Amendments to the Drawings:

Attachments: Replacement Sheet For Figures 2 and 9

FIG. 2

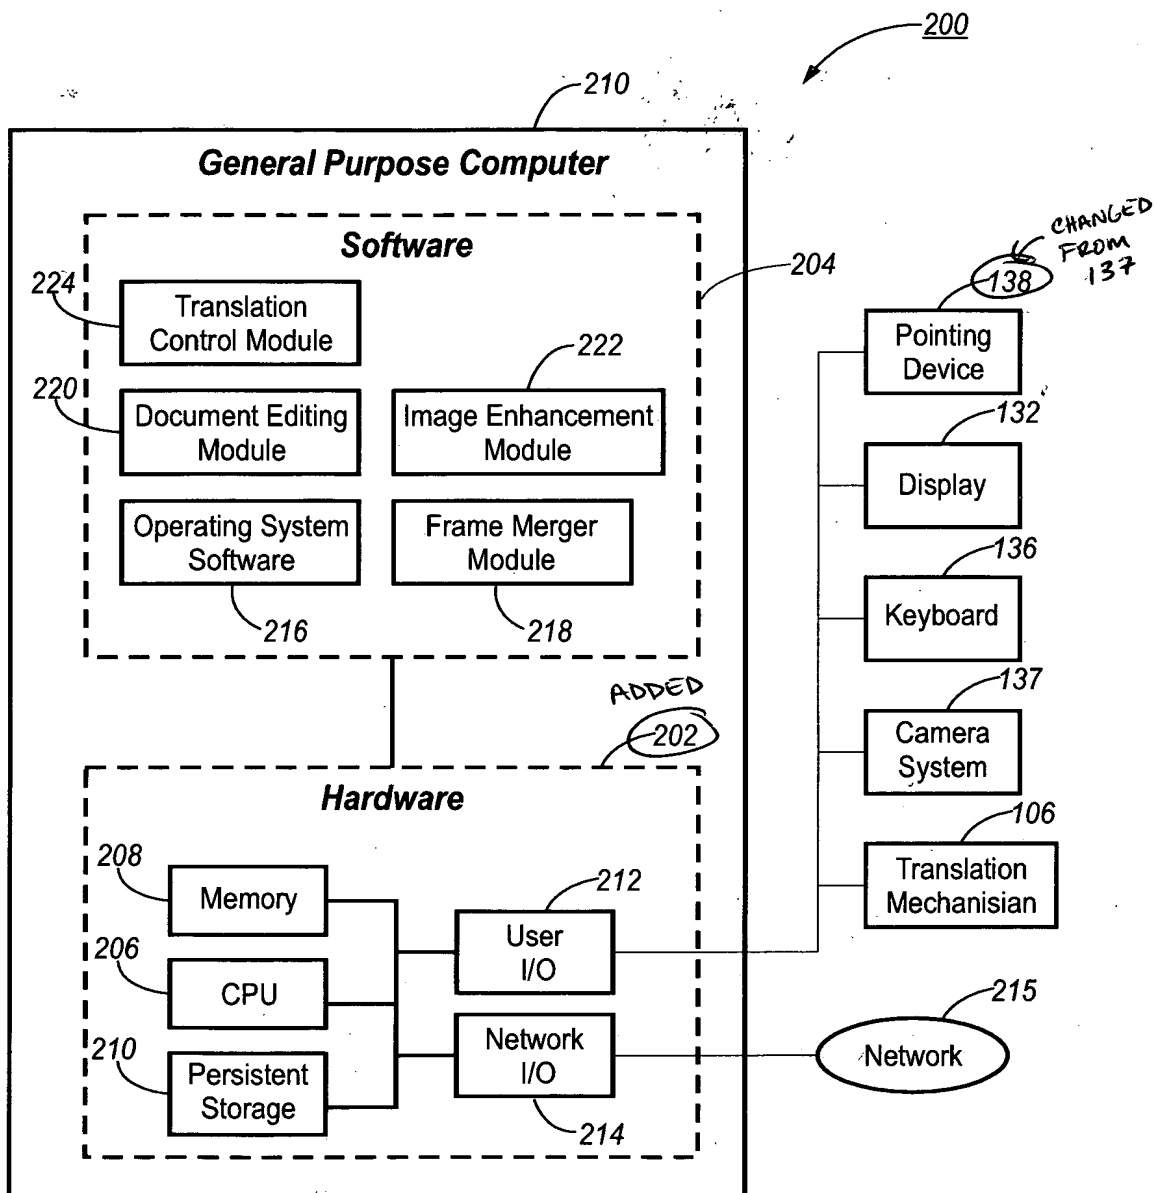
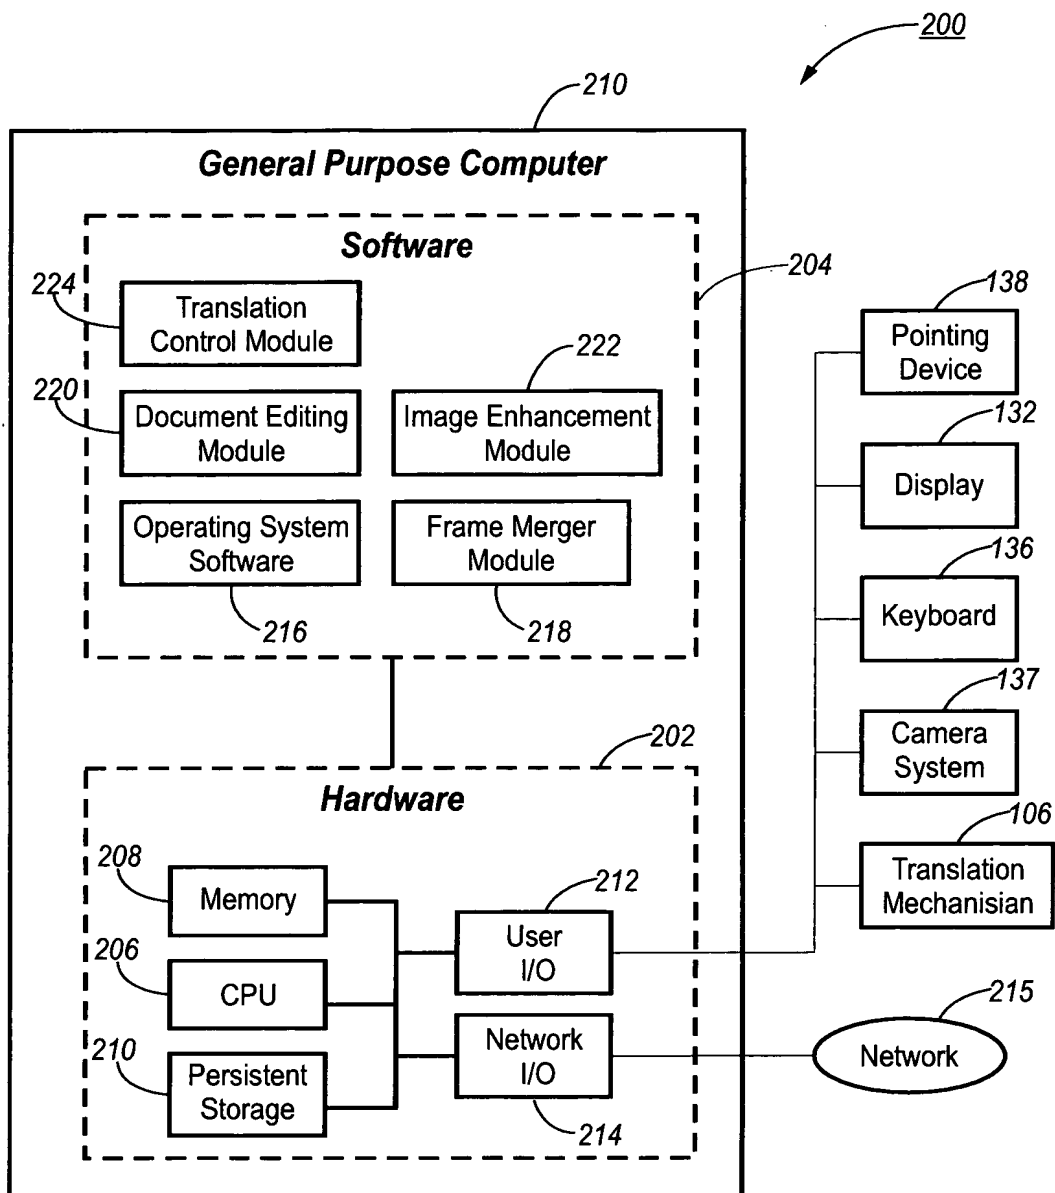
FIGURE 2: The attached sheet of drawings includes changes to Figure 2. This sheet replaces the original sheet. In Figure 2, omitted element 202 has been added and duplicate element 137 ("Pointing Device") has been renumbered as element 138. These changes are identified in the Annotated Sheet Showing Changes for Figure 2 also attached.

FIG. 9

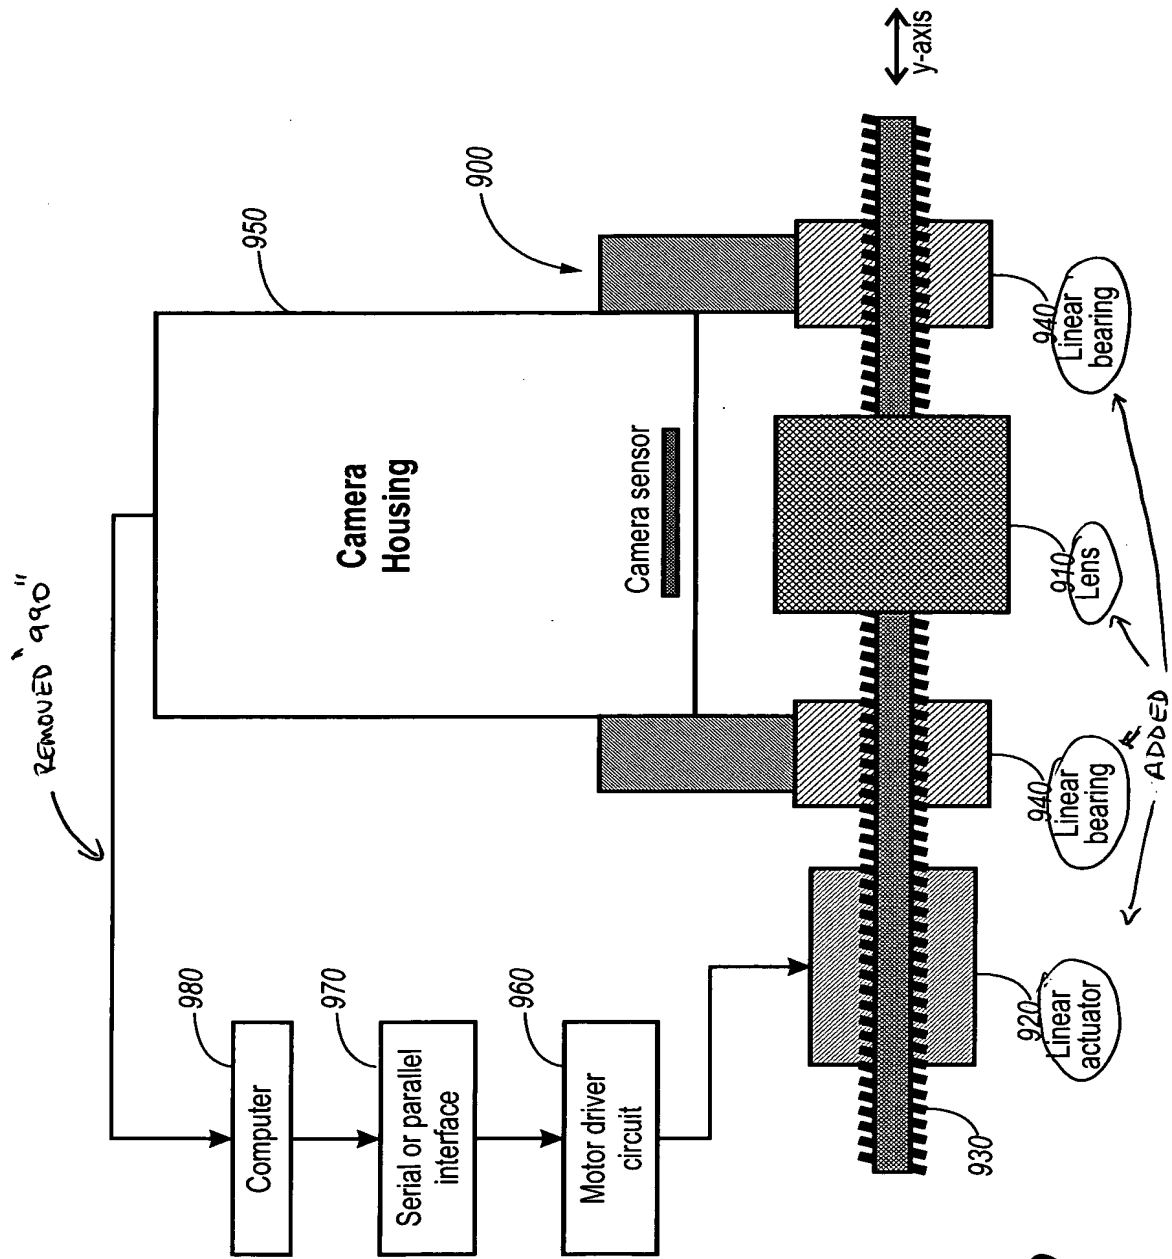
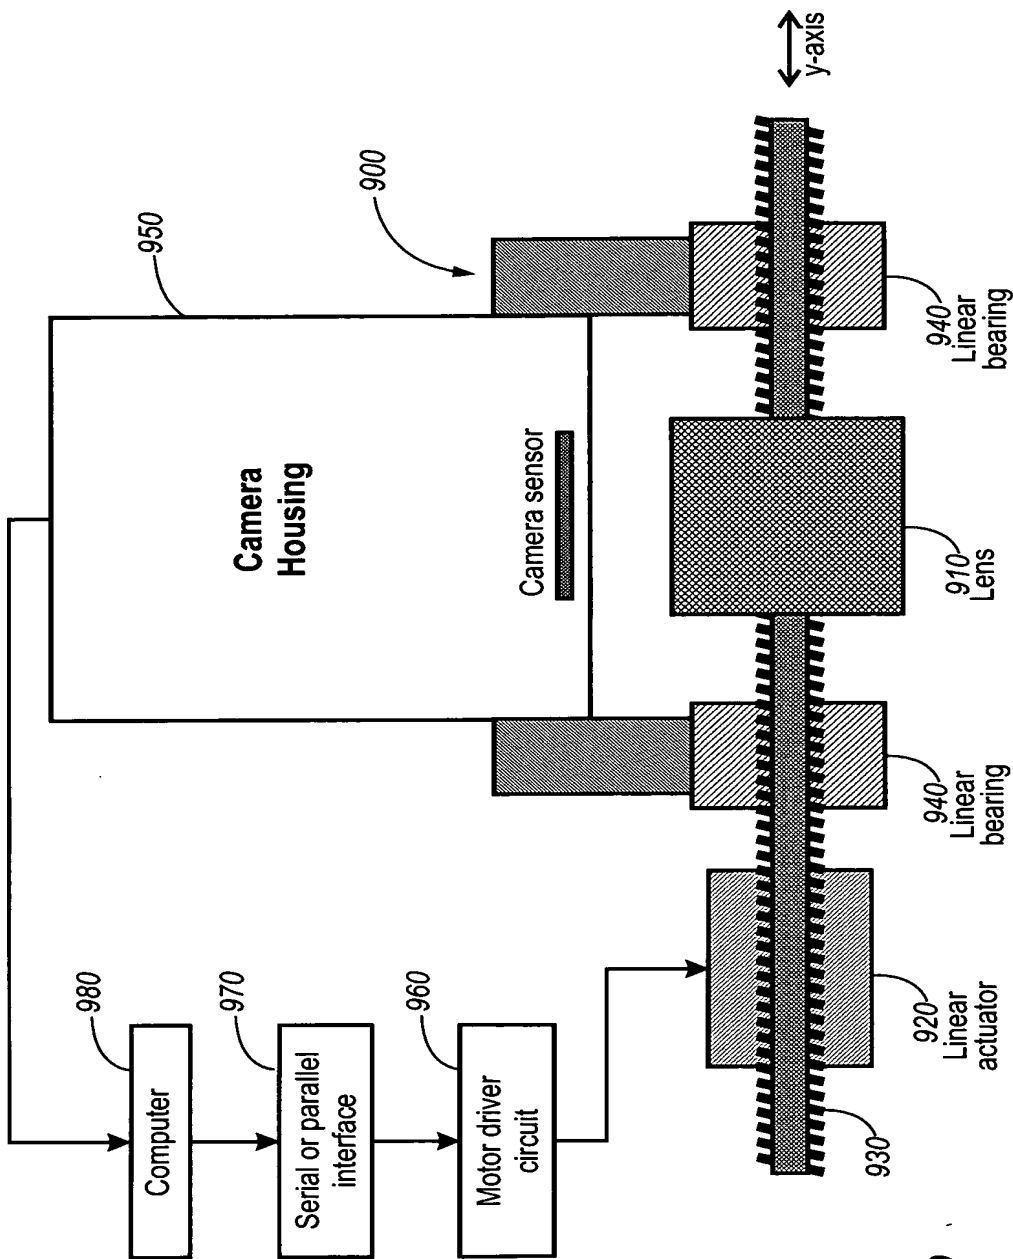
FIGURE 9: The attached sheet of drawings includes changes to Figure 9. This sheet replaces the original sheet. In Figure 9, element 990 has been removed for not being referred to in the specification, and textual references to elements 910, 920, and 940 that were present in the informal drawings filed with the Application but erroneously omitted during preparation of formal drawings have been added. These changes are identified in the Annotated Sheet Showing Changes for Figure 9 also attached.
